Our Ref: **GDTC0100/06:DS**

Monday, March 23, 2026

RE: 1-7 GOLDTOWER STREET AND 9 GOLDTOWER STREET, QUEENTON, LOT 1 & 2 ON SP326358 (MCU2026/0002) – RESPONSE TO INFORMATION REQUEST IN RELATION TO MATERIAL CHANGE OF USE APPLICATION

| Drawn | In Association With | LAYOUT PLAN GRADES AND LEVELS |

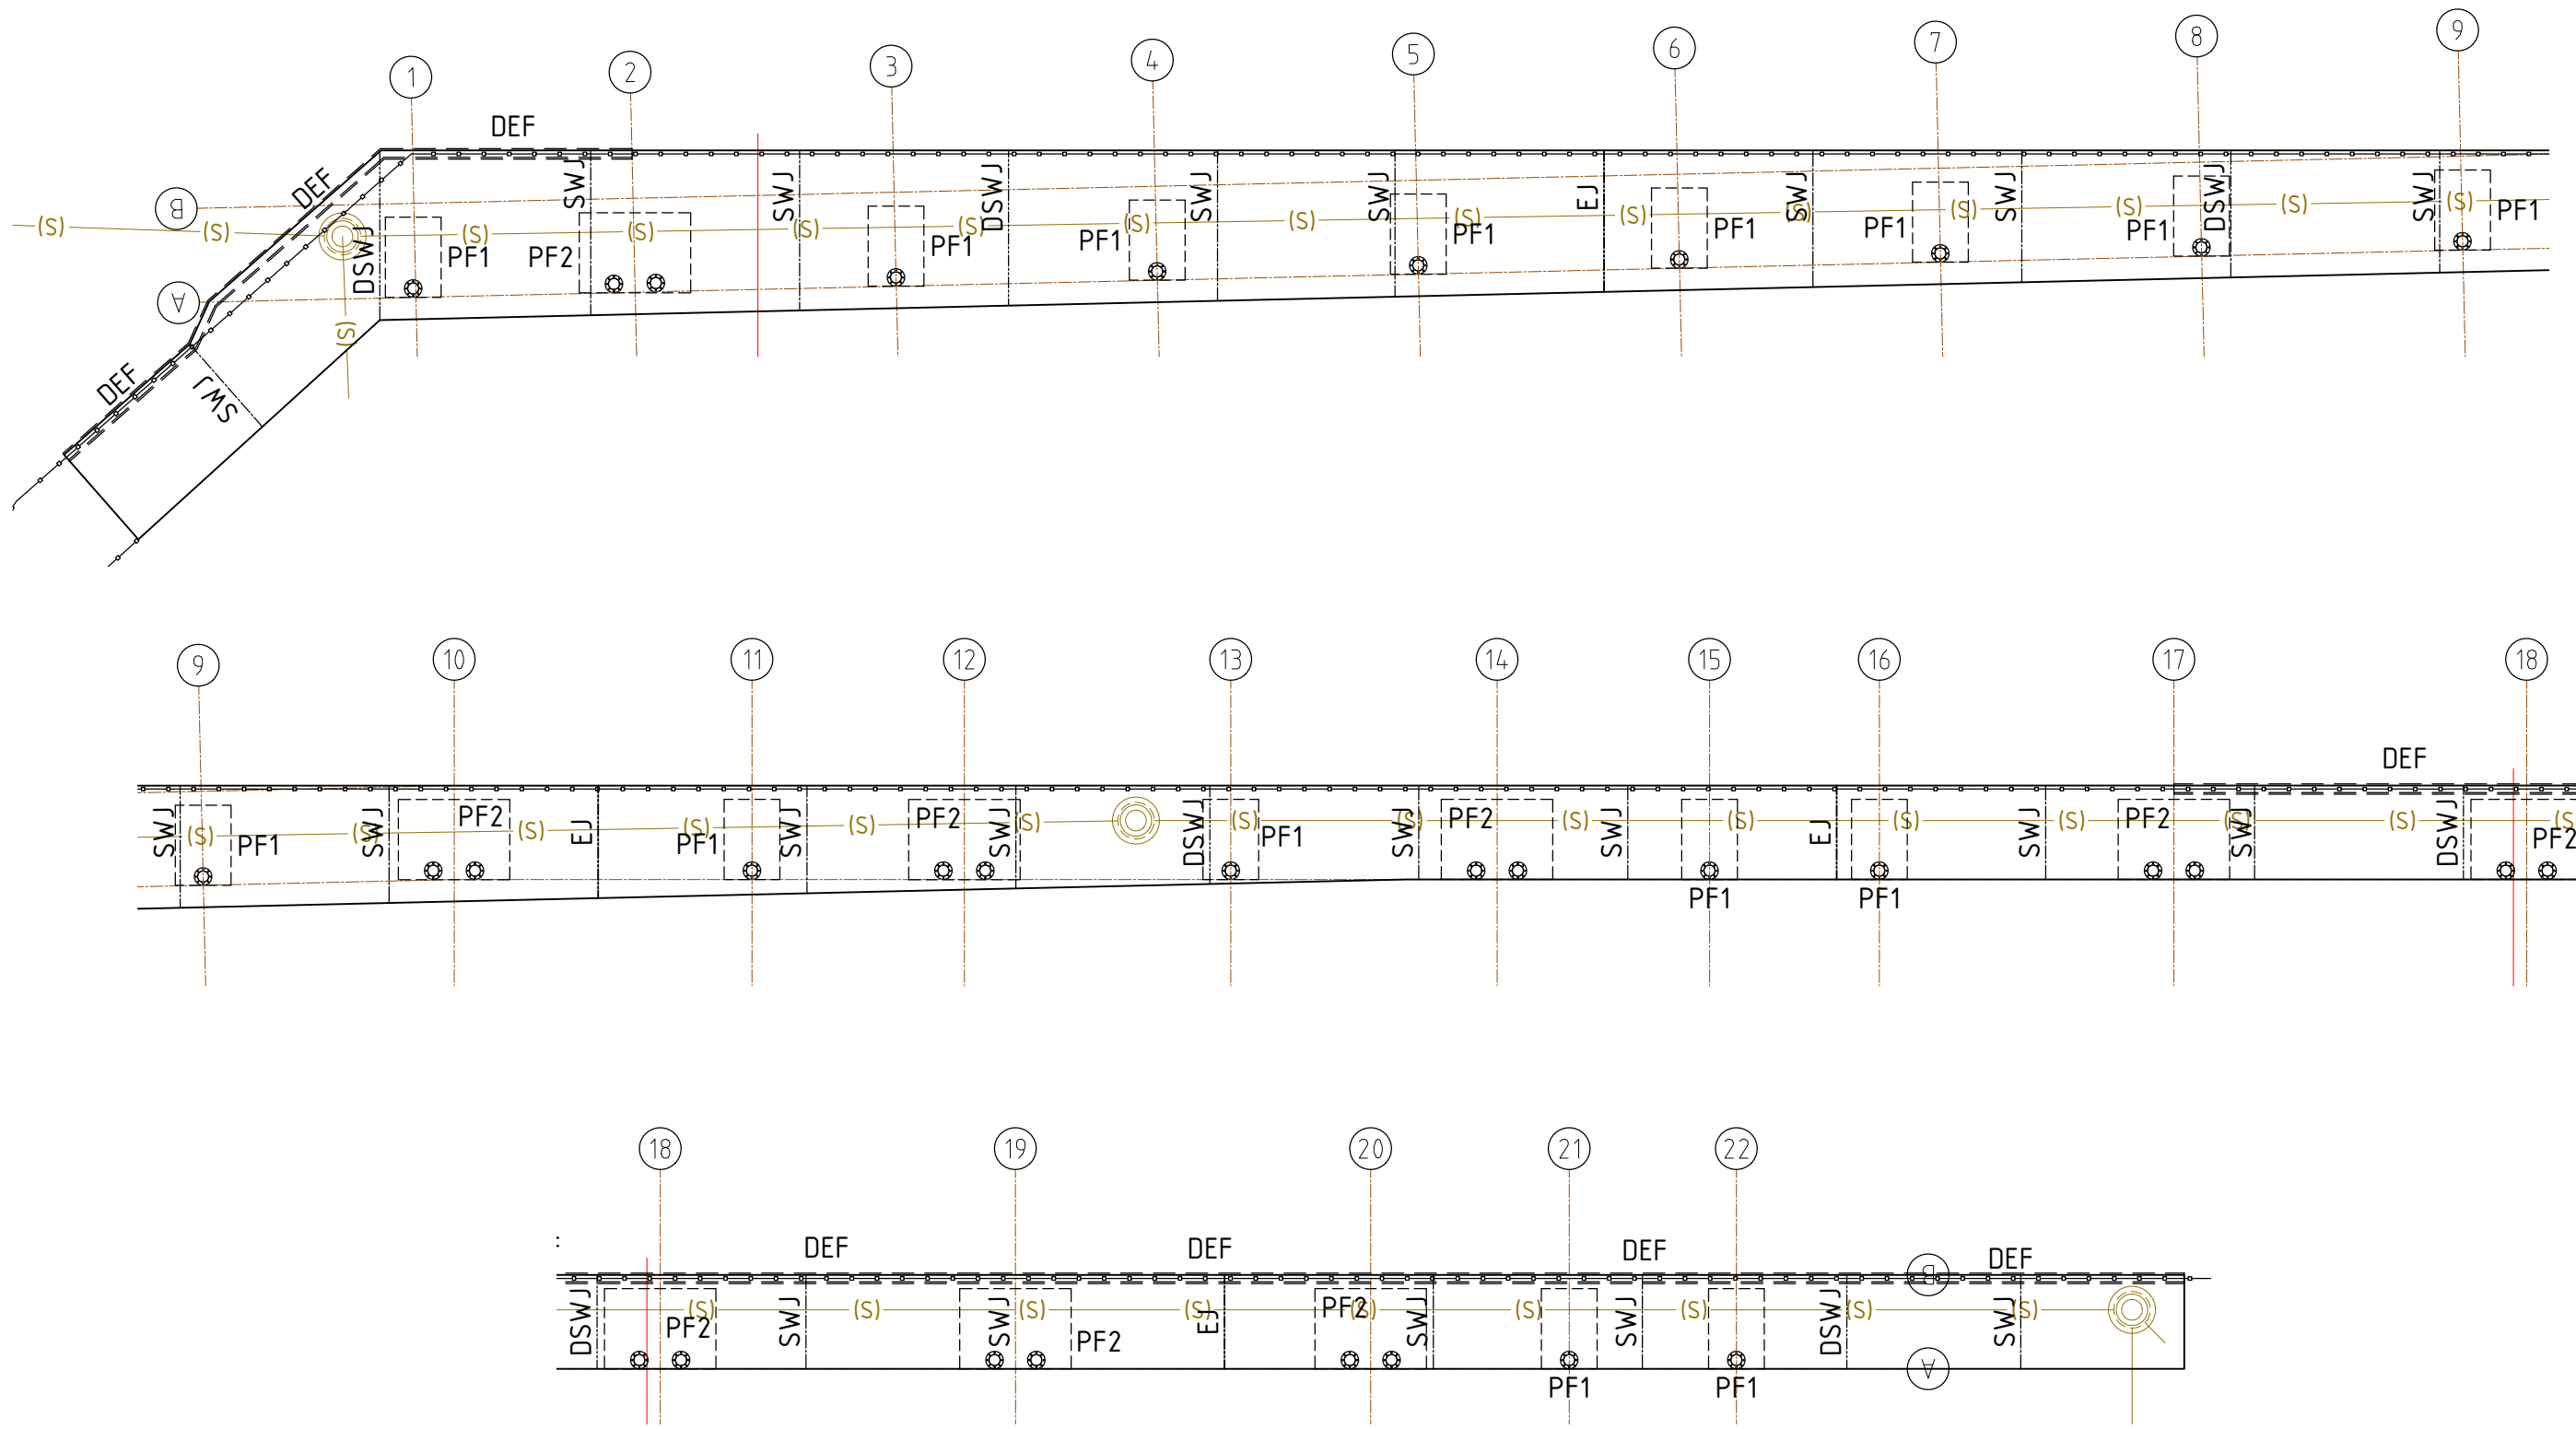
As a publicly accessible structure, Council seeks to confirm whether the proposal intends to provide universal access to all intended users.

- 2) Provide, to the satisfaction of Council and the applicable legislation, that the structure is not required to integrate universal access; OR
- 3) Demonstrate that the proposal is compliant with the applicable legislation.

The applicant wishes to thank the Council for the opportunity to review the accessibility code compliance. In completing the review NCE have identified several inconsistencies.

The applicant provides up dated plans inclusive of level modifications ensuring ramp grades and platforms remain compliant against AS1428 guidelines.
